Subject: Dresden Station Unit 2
Reload 4 Cycle 7 Supplemental
Reload Licensing Submittal
NRC Docket No. 50-237

APPLICABLE TO:
PUBLICATION NO. NEDO-24160
T. I. E. NO. 78NED294
TITLE Supplemental Reload
Licensing Submittal for
Dresden NPS Unit 2 Reload 4
ISSUE DATE November 1978

ERRATA And ADDENDA
SHEET

Figure 9. Decay Ratio

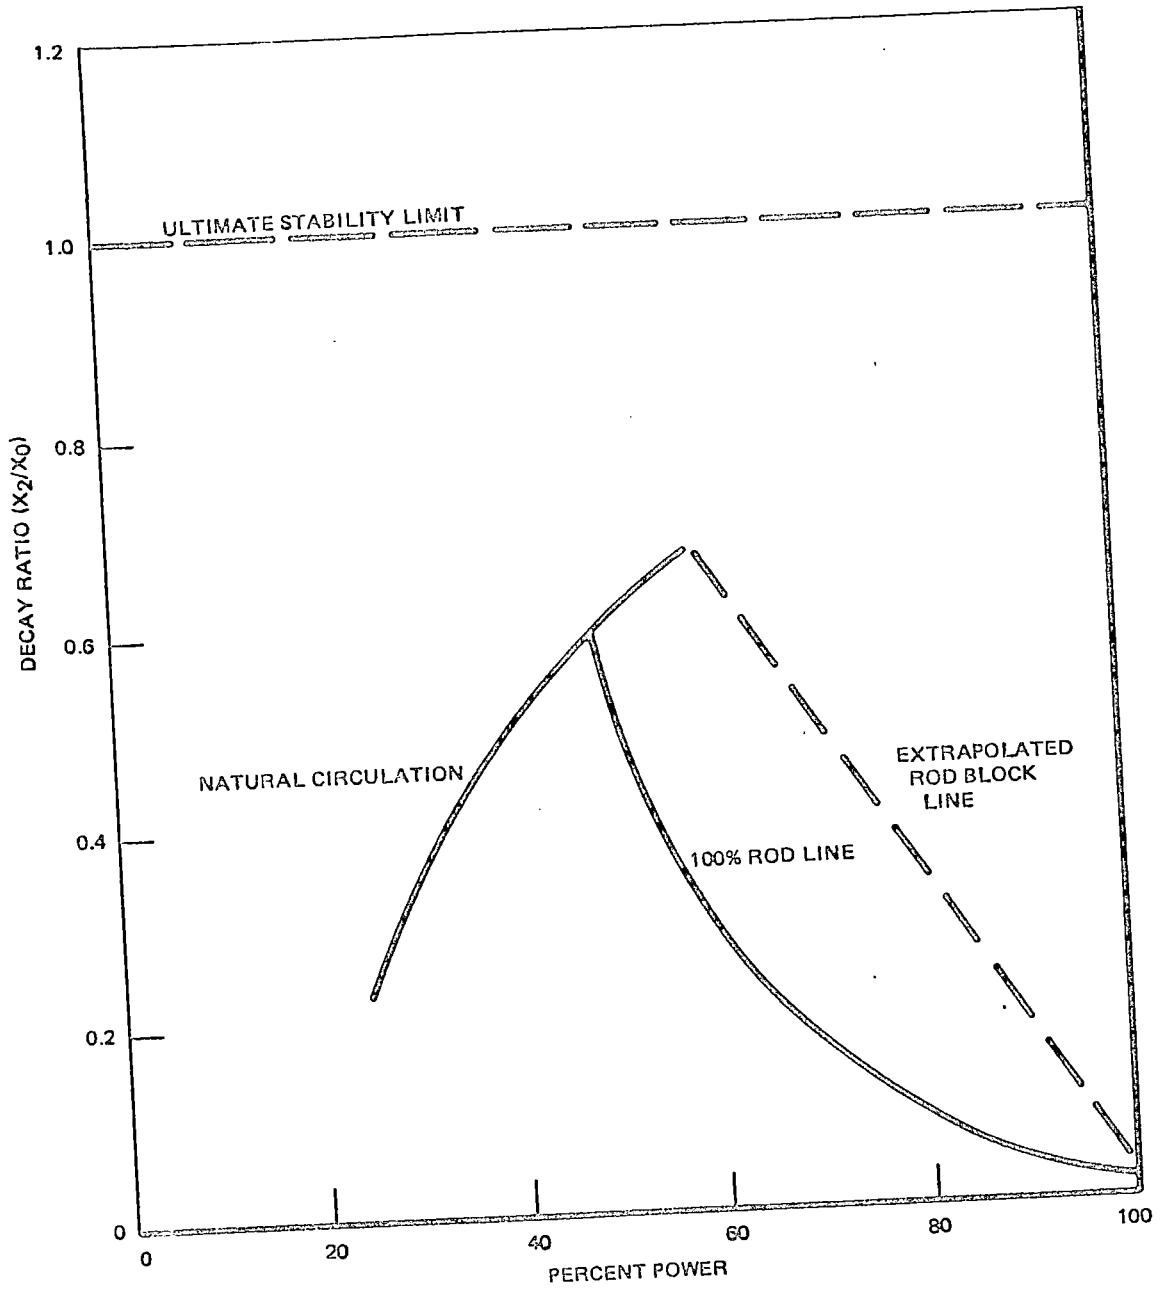
These changes merely add stability data for the extrapolated rod block line. The original submittal only presented decay ratios associated with the 100% power/flow line.

Natural Circulation/Extrapolated Rod	
Block Decay Ratio (see Figure A-1)	0.68
